HISTORIC LANDMARK COMMISSION STAFF REPORT

Foshee Shed
PLNHLC2010-00196
Central City Historic District
805 Park Street
June 2, 2010

Attachment A
Site Plan & Drawings

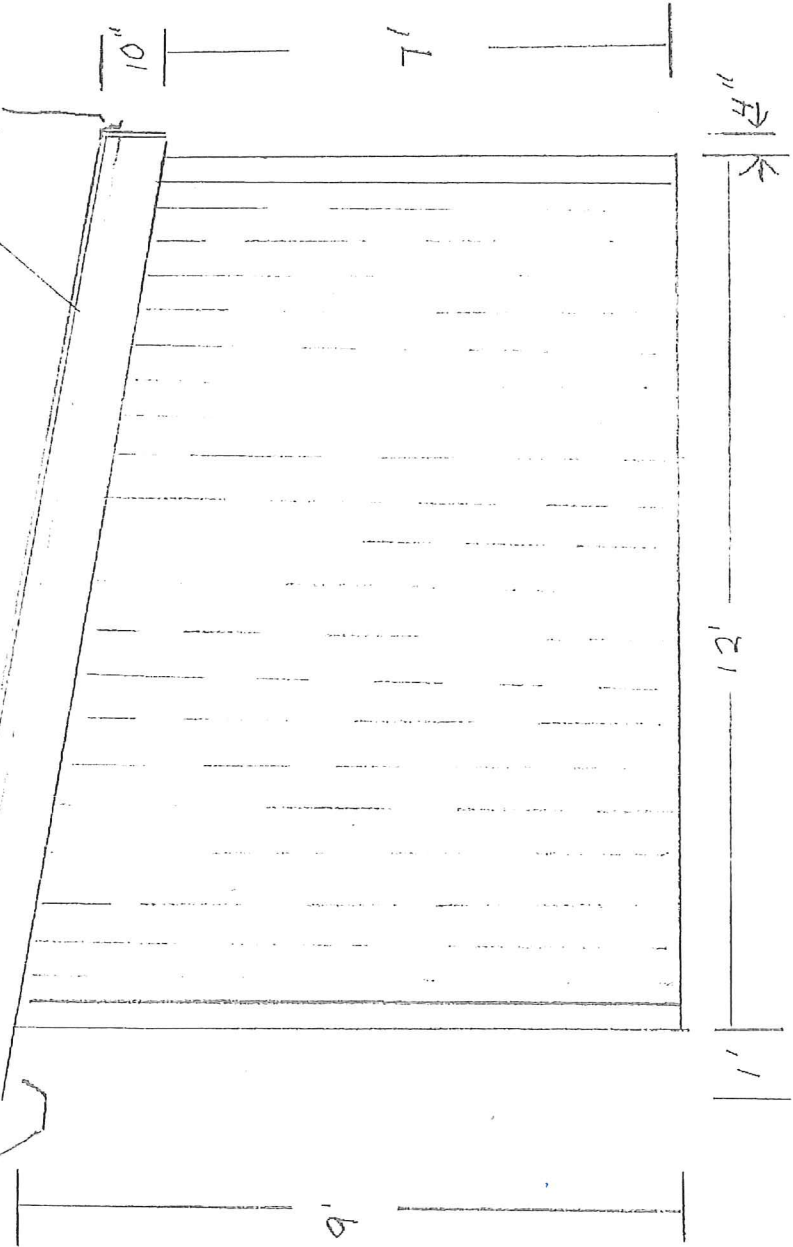
Analysis: The siding requested by the applicant is fiber cement panels with vertical orientation with a faux wood grain that imitates a board and batten look. The brochure for this product also shows a fiber cement panel that has a smooth finish. Alternative materials such as fiber cement products have been approved for new construction by the Historic Landmark Commission in the past. However the Historic Landmark Commission discourages the use of faux wood grain in favor of a smooth finish on fiber cement lap siding to match appearance of historic wood siding seen traditionally.

Finding: Although Standard 13.9 relates to the Avenues Historic District, it is the only reference to panel modules in the Design Guidelines and although it states that modular panels are inappropriate for principal structures, it also points out that panels on secondary buildings may be considered. Therefore, staff finds that the project meets the intent of this standard.
